Re: Minor Project Refinement No. 4 for the Round Mountain 500 kV Dynamic Reactive Support Project

Round Mountain 500 kilovolt (kV) Dynamic Reactive Support Fern Road Substation Project CPUC Minor Project Refinement Form

Report No.: 4

MPR-4
Figure 1

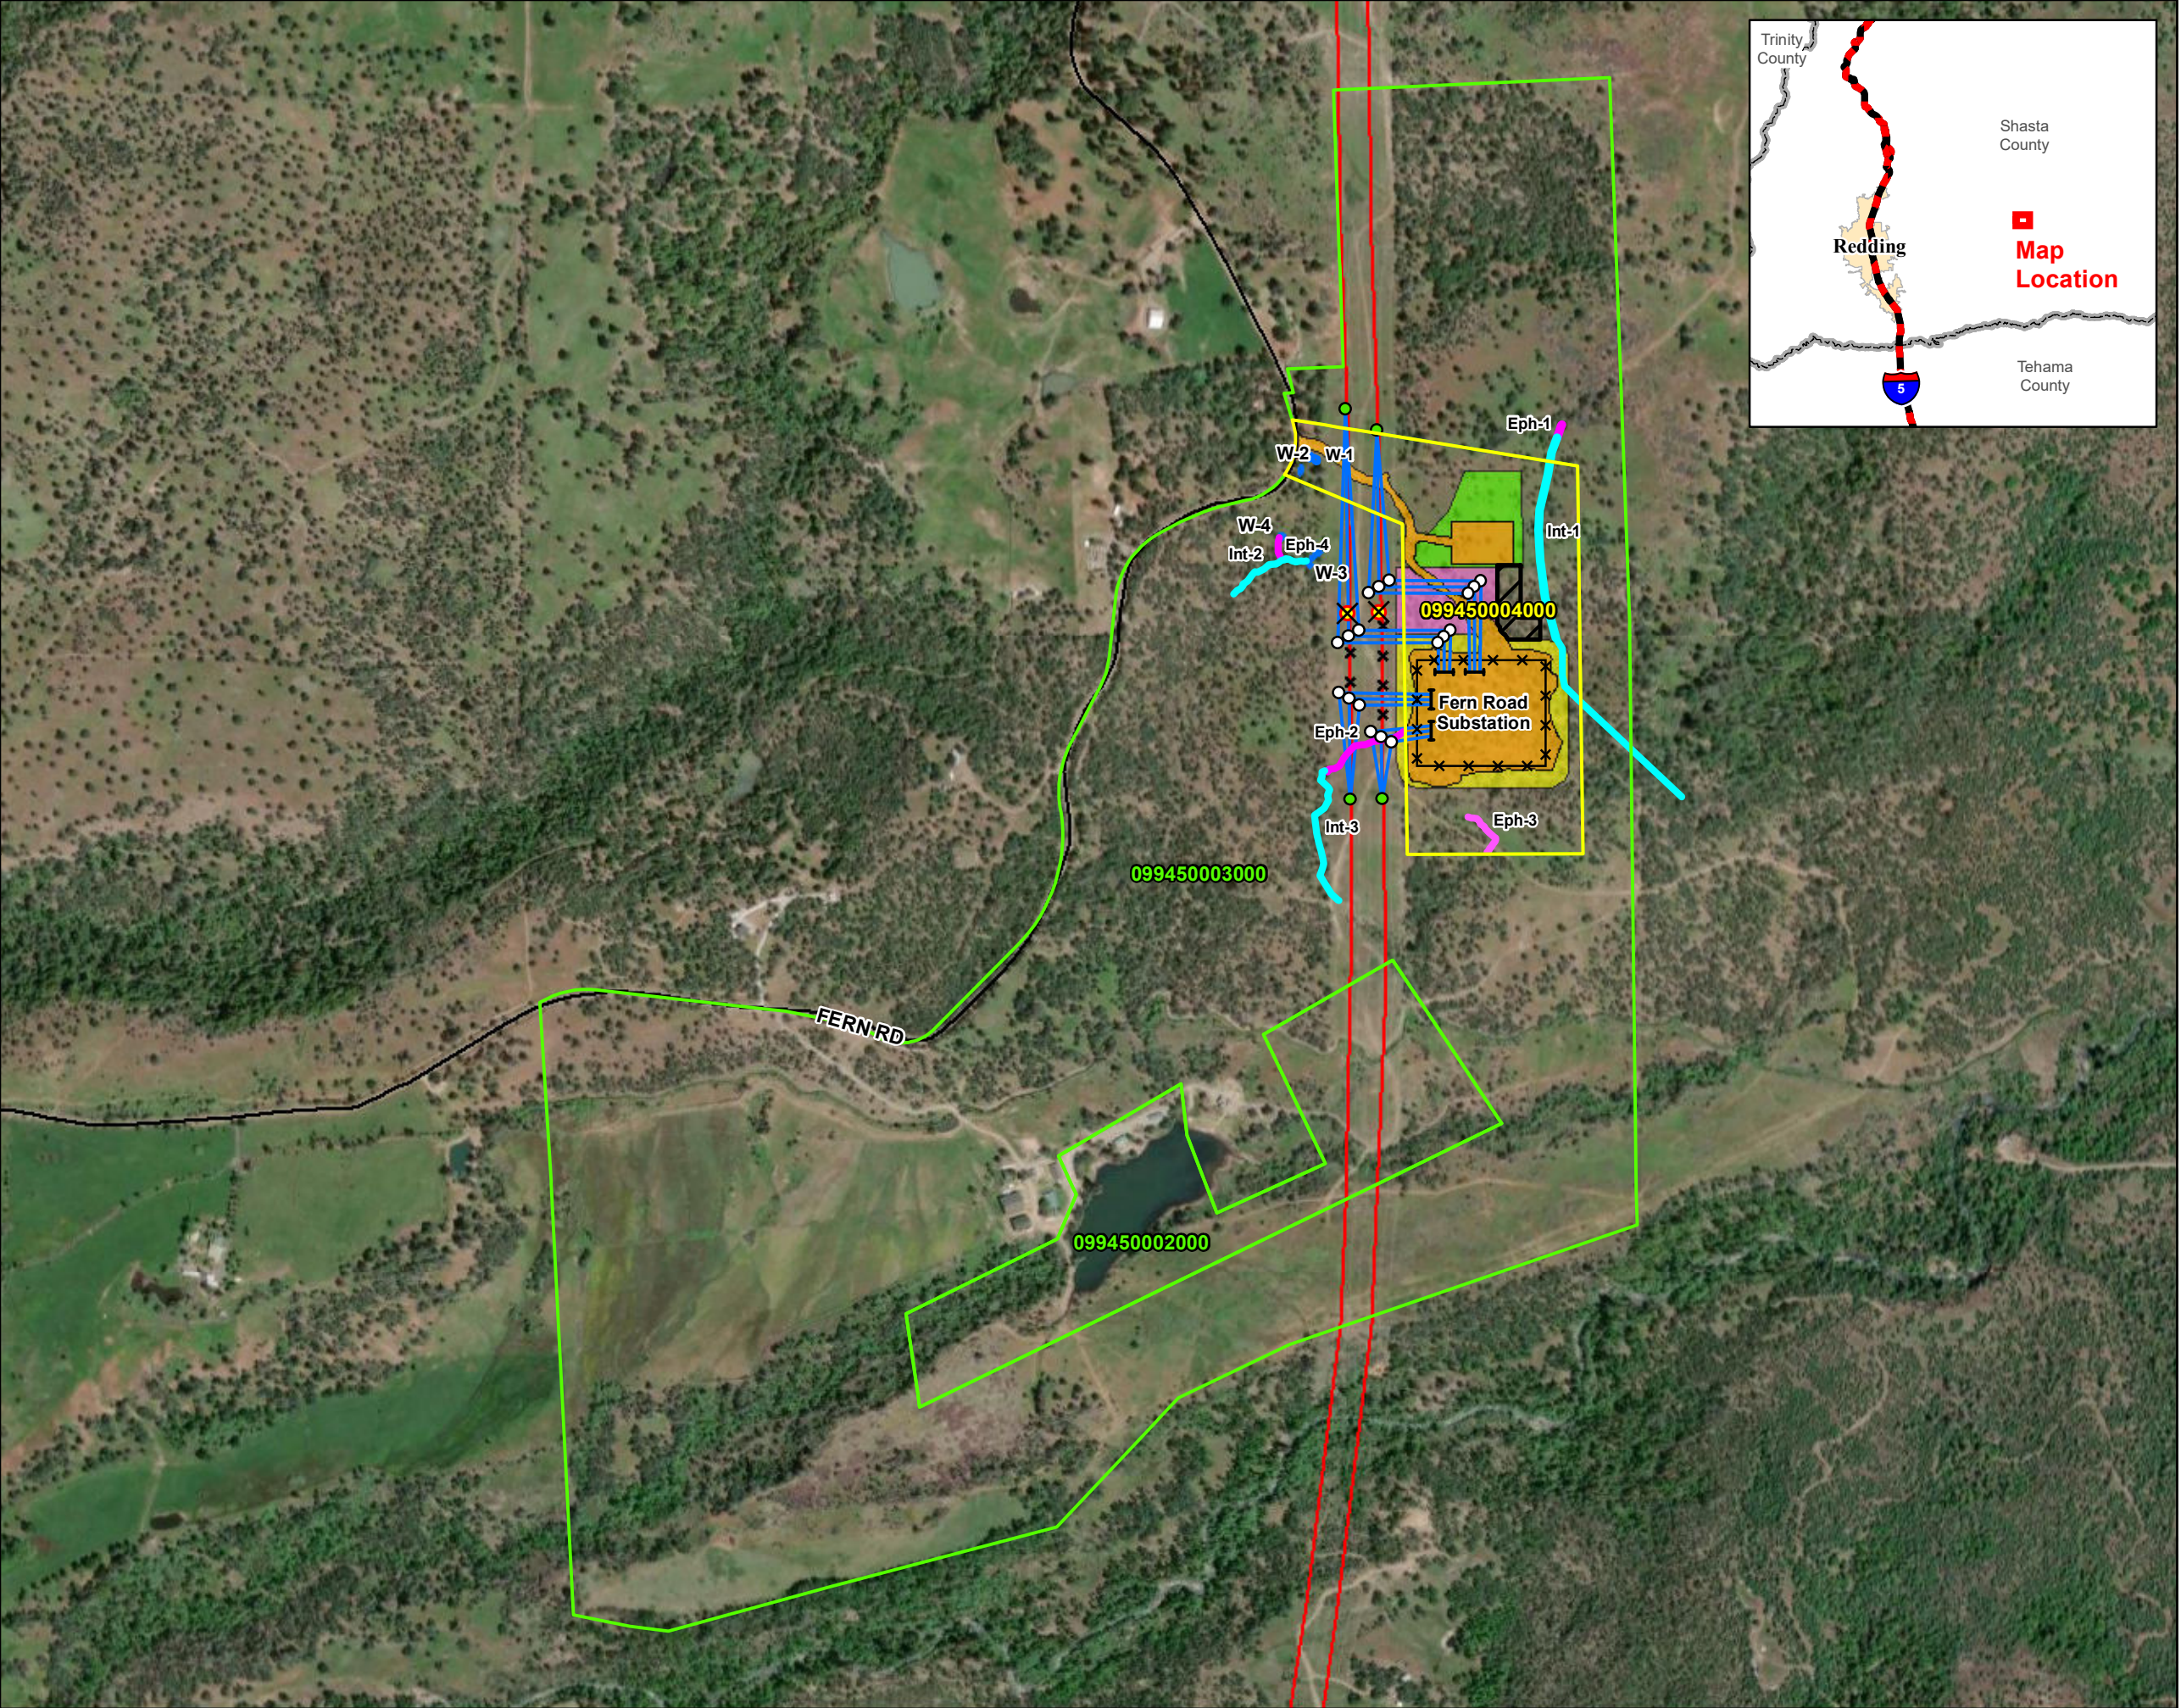
Maps & Figures: Refer to **Attachment B, MPR-4 Figure**, for a map showing the LSPGC property boundary in relation to the adjacent private property where the soil would be provided. Refer to **Attachment C, MPR-4 Aerial Photograph**, for an overview photo of the current Project layout, including sources for surplus soil.
